IN THE DRAWINGS:

Fig. 2

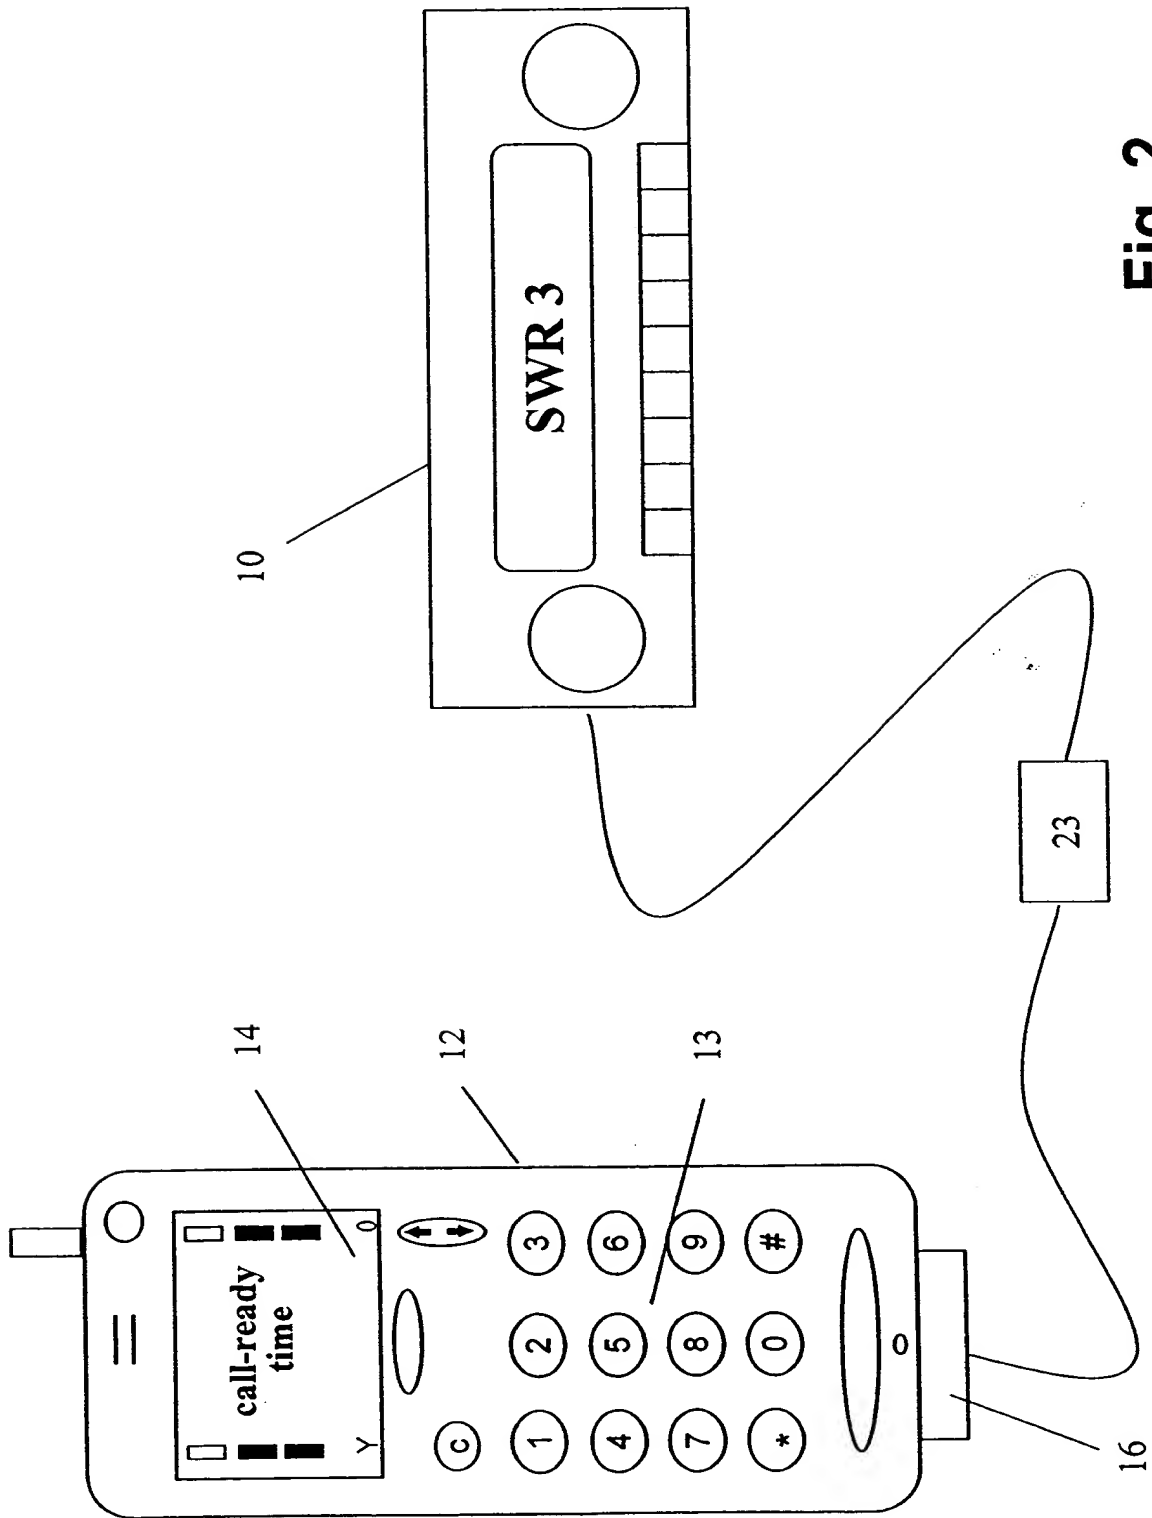
Please amend Fig. 2 to have element 14 read "call-ready time" instead of "Tracking time" as shown on the attached drawing sheets.
